HISTORIC AND DESIGN REVIEW COMMISSION

June 19, 2019

HDRC CASE NO: 2019-284
COMMON NAME: ROW near 1119 N ST Marys
ADDRESS: 1119 N ST MARYS
LEGAL DESCRIPTION: NCB 820 BLK 30 LOT 3, 4, 5 & 6
ZONING: FBZ T5-1, RIO-2
CITY COUNCIL DIST.: 1
APPLICANT: Kevin Bowyer/Verizon Wireless (c/o Modus Inc)
OWNER: DELGADO JOHN F
TYPE OF WORK: Installation of a new pole for network node equipment
APPLICATION RECEIVED: May 17, 2019
60-DAY REVIEW: July 16, 2019
CASE MANAGER: Huy Pham
REQUEST:

The applicant is requesting a Certificate of Appropriateness for approval to install a new wood pole for network node equipment in the right-of-way near 602 N Alamo (29.434912, -98.487019).

ELEVATIONS

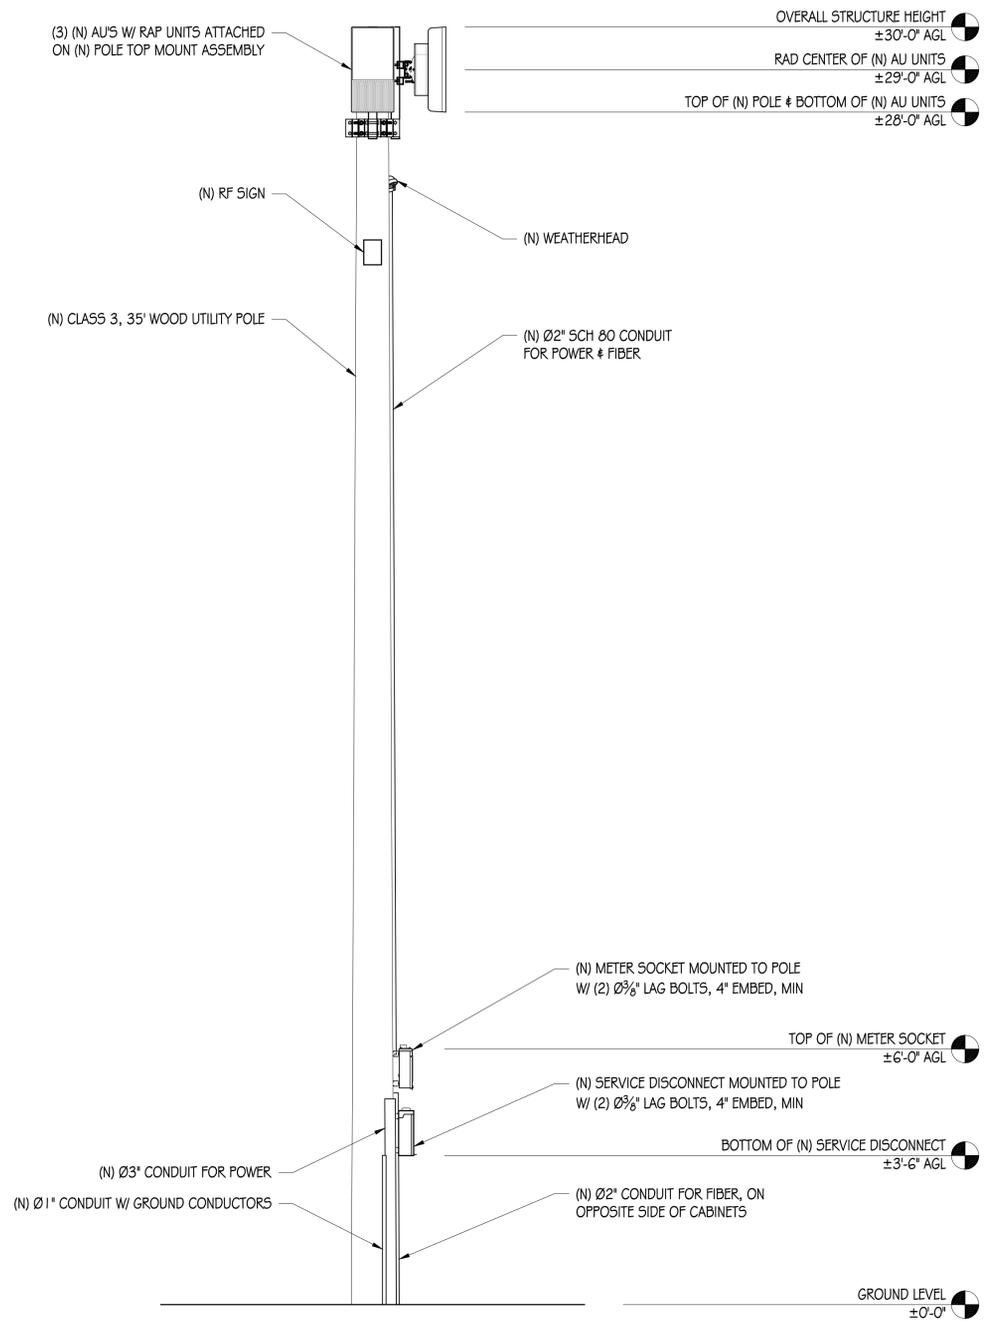
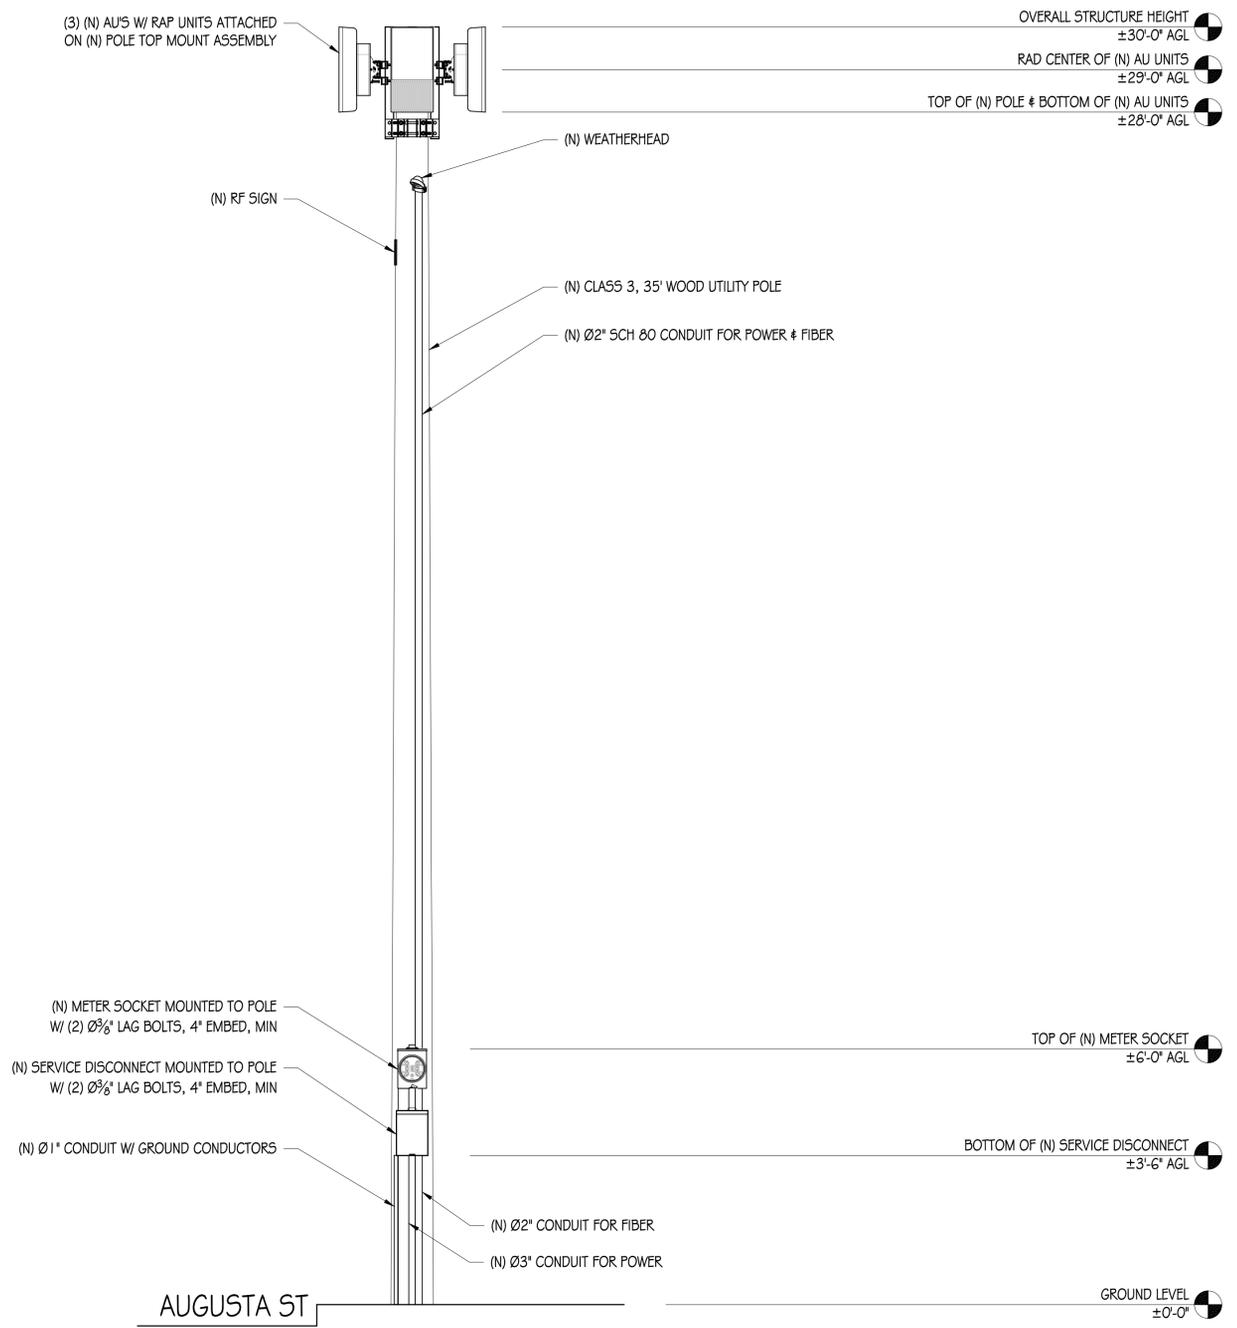
- g. HEIGHT – The applicant has proposed to install a wood pole including node equipment featuring a total of thirty feet (30') from grade. Per the Design Manual 3.B.iv., the height of new node support poles should not exceed the established predominant height of other poles and historic site elements located within 500 feet of the proposed installation. Staff finds that the proposed height is subordinate to existing poles within proximity.

- h. DIAMETER – The applicant has proposed to install a pole that is 32 inch (32”) in diameter excluding the meter boxes at the pedestrian level and the antenna cabinets at the top. Per the Design Manual 3.B.v., new poles should not exceed 8 inches (8”) in diameter at the widest portion of the pole. Staff finds that the proposed pole diameter is four times wider allowed by the design manual.

- i. DESIGN – The applicant has proposed to install a wood pole with a meter socket (box), service disconnect (box) and linear conduit up to six feet (6’) and three (3) au/rap units (grey cabinets) that are 11.4 inch wide, 14.6 inch tall, and extend no more than one feet (1’) from the wood pole. The applicant referenced existing wood utility poles in selecting the pole type in this location. Per the Design Manual 3.B.: *The Historic Preservation Officer may require concealment of the support pole in the form of aesthetically appropriate street lamps, site elements, district signage, or other stealth methods. The color of any new support pole or concealment solution shall be determined by the Historic Preservation Officer based on site specific conditions.* Staff finds that no effort has been made to conceal or relate the proposed new pole to the existing context or site elements at N Mesquite – except the use of a wood pole and matching equipment color.

- i. COLLOCATION - Documented efforts to explore a nearby collocation have not been submitted.
- ii. SEPARATION – The proposed pole is not separated from existing poles by more than 250 feet.
- iii. DIAMETER – The proposed pole is not less than 8 inches at its widest portion.
- iv. DESIGN – Matching wood material to existing poles does not constitute a stealth aesthetic.
